Report to the Future Melbourne Committee**Agenda item 6.4****Ministerial Planning Referral: TPM-2022-20
559-577 King Street, West Melbourne****24 October 2023****Presenter:** Nick McLennan, Acting Head of Statutory Planning**Purpose and background**

1. The purpose of this report is to advise the Future Melbourne Committee of a Ministerial Planning Application seeking approval for the development of land at 559-577 King Street, West Melbourne. The application also includes proposed works over a Council laneway, Corporation Lane 1091 (CL1091) (refer Attachment 2 – Locality Plan).

2. The application proposes the use and development of land for three multi-storey buildings ranging in height from six to ten storeys to be used for dwellings, food and drink premises and office (refer Attachment 3 – Selected Plans).

Figure 164 - Section AA

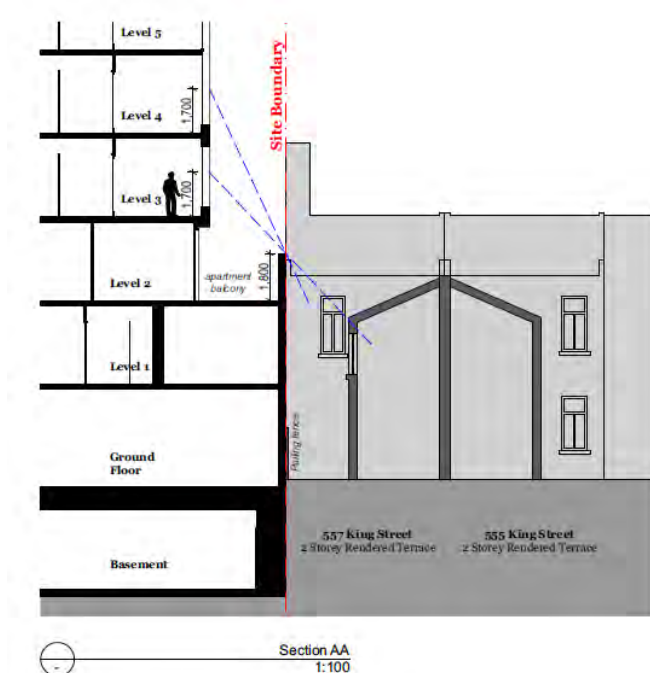
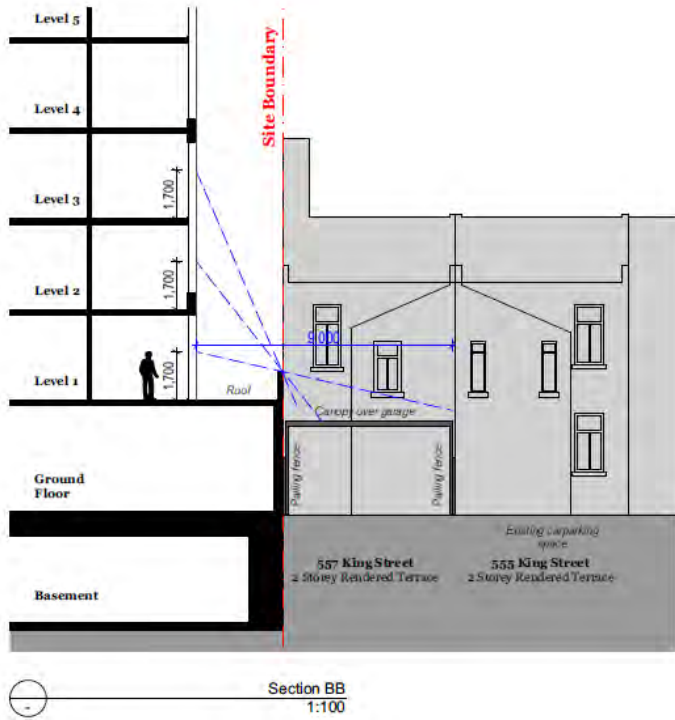
While the windows are not screened, the Applicant has provided section diagrams to identify that screening is not required. Refer to Figures 24 and Figure 25.

Section AA shows that from Level 3 above, no overlooking would be achieved due to an apartment balcony associated with Level 2. A review of the floor plans show that there are no balconies associated with southernmost Level 2 – Dwelling 2.1A. There are balconies to southernmost Level 2 – Dwelling 3E, refer to Figure 26.

There is no certainty that there will be no overlooking impact to 557 King Street, particularly to the window as shown in Figure 27. In particular, the application does not confirm if this window is habitable and therefore consider it reasonable to protect.

The concern relates to potential view lines from Level 4 to Level 8. In addition, there are balconies to Level 8 associated with southernmost Dwelling 3B and Dwelling 2A.2 of which require clarity. It is considered that a condition could be imposed to provide clarity and address this concern.
